Economic Commission for Europe**Inland Transport Committee****World Forum for Harmonization of Vehicle Regulations****172nd session**

**1958 Agreement: Consideration of draft amendments
to existing Regulations submitted by GRSP****Proposal for Supplement 9 to the 06 series of amendments to
Regulation No. 16 (Safety-belts)****Submitted by the Working Party on Passive Safety***

Supplement 9 to the 06 series of amendments to Regulation No. 16 (Safety-belts)

Figure 7

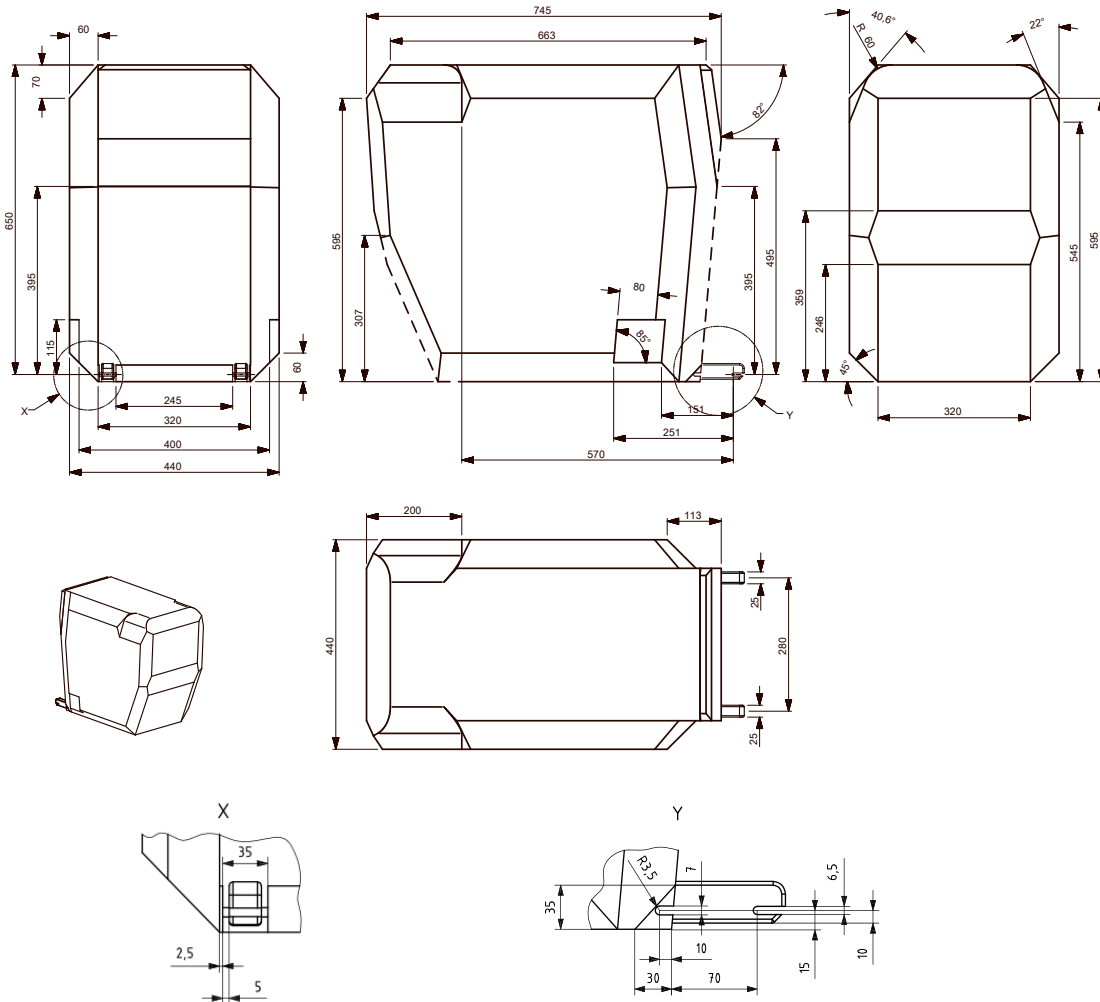
Appendix 2, insert a new paragraph 4.7. and a new Figure 7 to read:

"4.7. Rearward facing infant child restraint systems envelope ISO/R2X

Reduced-Size Rearward Facing toddler CRS Envelope dimensions for a reduced-size rearward-facing CRS, modified for improved compatibility with the vehicle interior

- 1 Limits in the rearward and upward directions
- 2 Dashed lines mark the area where an anti-rotation device, or similar (e.g. rebound bar), is allowed to protrude
- [3 The backward limitation (to the right in the figure) is given by the forward-facing envelope in Figure 2]
- 4 For further specifications of the connector area, see detail Y and ISO 13216-1:1999, Figures 2 and 3"

Figure 8

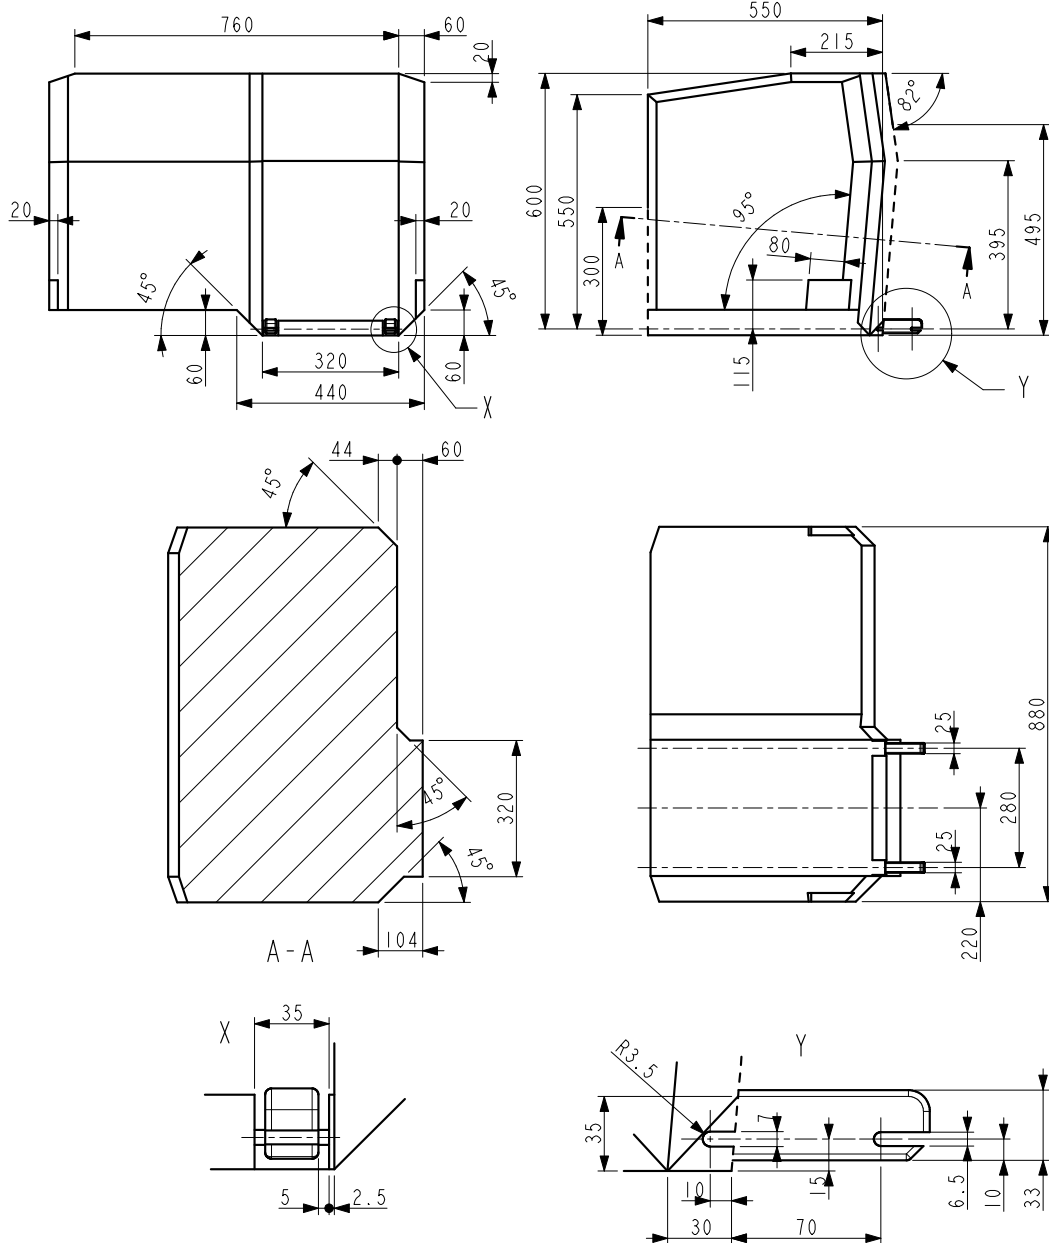
Appendix 2, paragraph 4.7.(former), renumber as paragraph 4.8. and amend to read:

"4.8. Lateral facing child restraint systems envelope

Envelope dimensions for lateral facing position CRS - ISO/L1- or symmetrically opposite - ISO/L2 (figure shown)

Note: The envelope for a left lateral-facing infant CRS (ISO/L1) has dimensions symmetric to ISO/L2 with regard to its intermediate longitudinal plan.

- 1 Limits in the rearward and upward directions
- 2 Dashed lines mark the area where an anti-rotation device, or similar (e.g. rebound bar), is allowed to protrude."

Figure 1
Positioning in seat

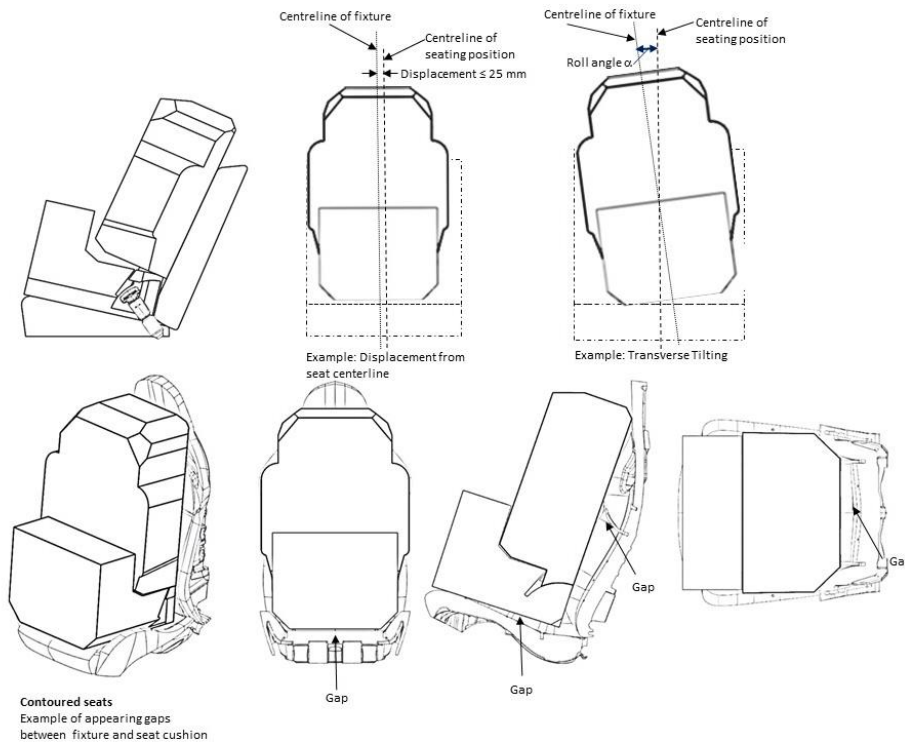
Annex 17, insert a new Appendix 5 to read:

- 2.10. Ensure that the fixture is located with its centreline on the apparent centreline of the seating position ± 25 mm with its centreline parallel with the centreline of the vehicle seat. The roll angle α (see figure 1) shall be within $0^\circ \pm 5^\circ$

3. Requirements
- 3.1. It shall be possible to secure the fixture in the seating position using the 3-point seat belt and to buckle up the seat belt.
- 3.2. The roll angle α as shown in Figure 1 shall be equal to or less than 5° .

- 3.3. The base of the fixture shall be in contact with the seat cushion, and the back face of the fixture shall be in contact with the seat back or head restraint. Full contact with the seat is not necessary, "gaps" due to the vehicle seats contours are permitted as shown by the arrows in Figure 1. The booster seat envelope is equipped with an adjustable backrest. Compatibility with the vehicle seating position shall be achieved in at least one position of the backrest range shown in Figure 2 or Figure 3.
